SERVICE DIRECTIVE BULLETIN

SDB T-026
Revision 1
Page 1 of 6

DATE: February 14, 2014

1. SUBJECT: Power Output Shaft Bearing Inspection
2. MODEL: TH-28, 480, 480B
3. EFFECTIVITY: TH-28 & 480: All serial numbers
480B: Serial numbers 5090 and prior
4. BACKGROUND:

Figure 1.

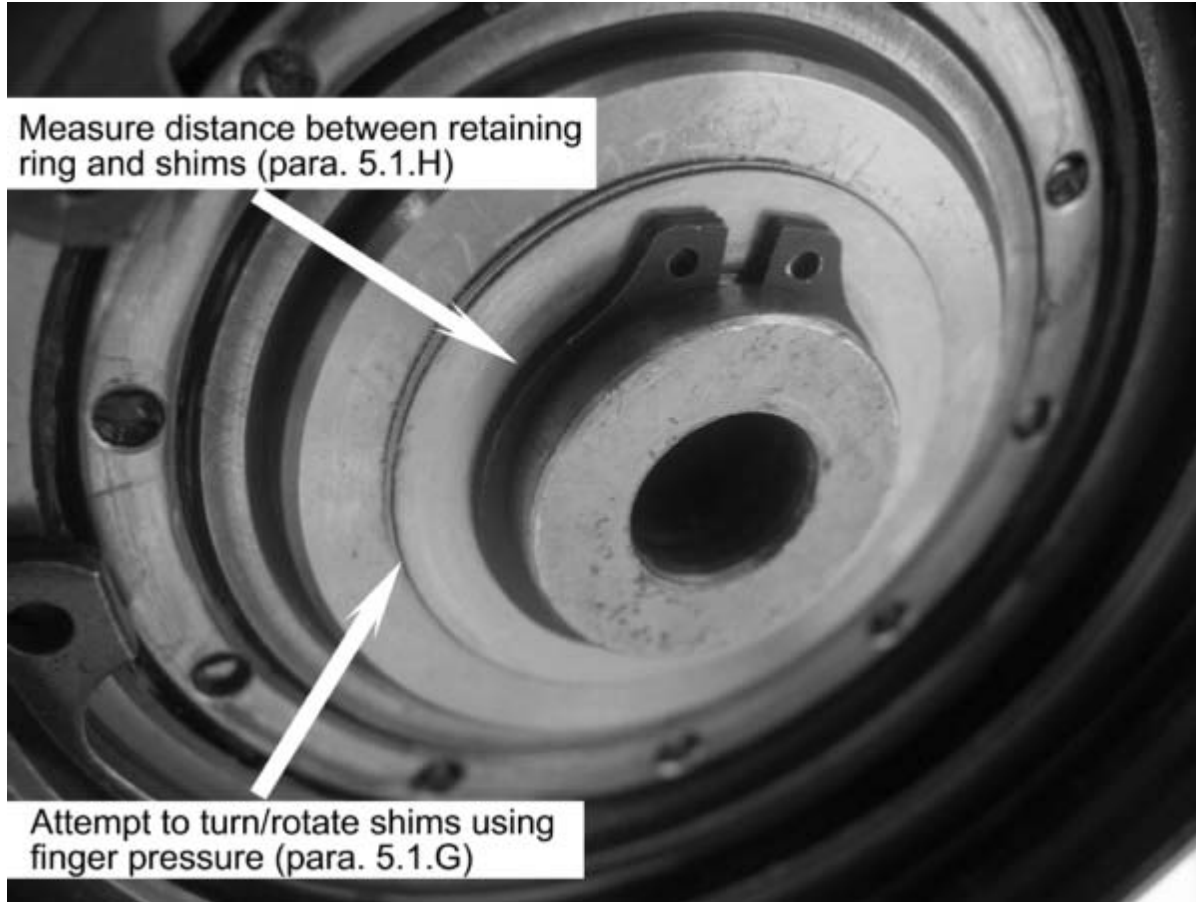
REVISION 1: Revised Compliance requirements; Paragraph 5.1.H(1) through (3) acceptable range is now .004" to .006" (was .002" to .004"); Added T-0186; Part number format update: now ECD4017 was ECD-4017; Deleted Step H(4); added applicable 4131001 dash numbers.

Since the initial release of this SDB, the shimming requirement has been revised (previously .002" to .004"; now .004" to .006").

- G. Using your fingers, attempt to turn/rotate the shims installed under the retaining ring on the end of the power output shaft (Refer to Figure 1).
- (1) If the shims cannot be turned/rotated using your fingers, remove the retaining ring from the end of the power output shaft and remove the shims. Separate and clean the shims. Reinstall the shims and retaining ring, and attempt to rotate the shims using your fingers.

- (3) Proceed to the next step (para. 5.1.H) if the shims can be turned/rotated using your fingers.
- H. Using a feeler gauge, determine the distance between the retaining ring on the end of the power output shaft and the shim(s) (Refer to Figure 1). Record distance on the SDB Report Sheet (Measurement 1).

- (1) If the distance between the retaining ring and the shim(s) is .004" to .006", no further action is required.
 - (2) If the distance between the retaining ring and shim(s) is greater than .006", remove the retaining ring and add shims until the distance is between .004" and .006".

- (3) If the distance between the retaining ring and shim(s) is less than .002", remove the retaining ring and shims and record the total thickness of shims on the SDB Report Sheet (Measurement 2). Recheck the aft end of the power output shaft for radial and axial play IAW para.5.1.C.; replace the bearing as required. If no radial or axial play is evident, reinstall the retaining ring and adjust the shim(s) to the .004" to .006" distance. Determine the difference between the thickness of the original shim installation verses the thickness of the adjusted installation. Record the difference on the SDB Record Sheet (Measurement 3).
